**Comfort Inn & Suites  
Planning Board Review  
August 15, 2025**

Bristol, RI

**BTGA No. 2512**

#### **Site Plans**

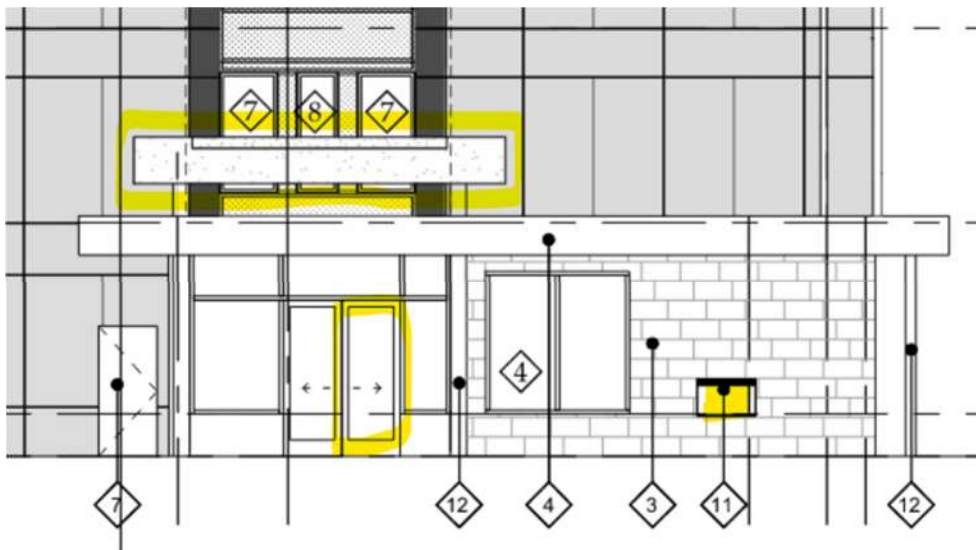
1. Revise the site plan to represent the residential neighbor's driveway and structures accurately.
2. Existing trees depicted appear to be fewer than those shown on Google Street View. A dense line of trees is seen along the residential neighbor's property and Gooding Avenue. Confirm tree placement is accurate.
3. Provide retaining wall design intent including heights and materials.
4. See recommendations throughout for recommended additional site requirements.
